CITY OF VANCOUVER
COMMUNITY SERVICES GROUP

DEVELOPMENT PERMIT STAFF COMMITTEE REPORT
FEBRUARY 15, 2006

1808 WEST 3RD AVENUE (COMPLETE APPLICATION)
DE409776 - ZONE C-3A

4 North Elevation : Massing Comparison
 Scale: 1/8" = 1'-0"

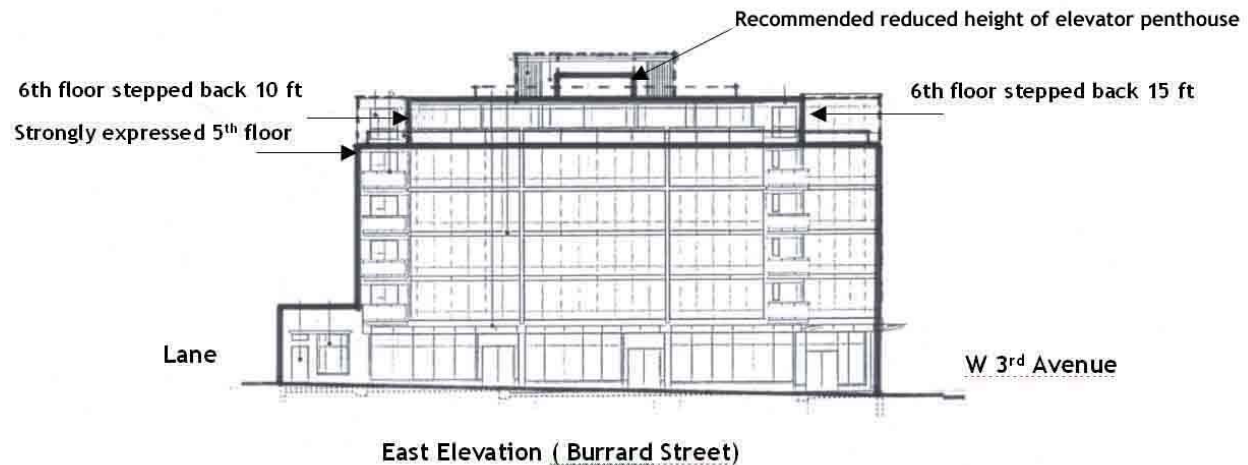
Built Form, Massing and Height: The Guidelines provide for a relatively close massing relationship to the adjacent westerly neighbour with a 5 ft (1.5 m) setback and a 30 ft (9.1 m) height along the length of the sideyard. This would allow considerable building volume that could achieve the maximum conditional density of 3.0 FSR. Although the adjacent site is split zoned, the neighbouring building has

• **Conclusion:** This development application proposes a maximum density of 3.0 FSR and height of six storeys, one floor higher than the recommendation of the Guidelines. Staff consider that discretionary earning of increases to floor area and height will be achieved by the following:

- 1.1 design development to significantly reduce the sixth floor massing to present a predominately five storey scale on the streets;
- Note to Applicant:** This can be achieved by stepping the sixth floor back approximately 15 ft (4.5m) on the W 3rd Avenue frontage and 10ft (3.0m) on the lane frontage. This setback area should be developed as private decks (to replace the roof decks deleted as noted under condition 1.2). Floor area lost in the reduction of the sixth floor may be recovered on lower floors by slightly increasing building width (i.e. small decrease of approximately 2 ft / .6 m) in the west side yard.
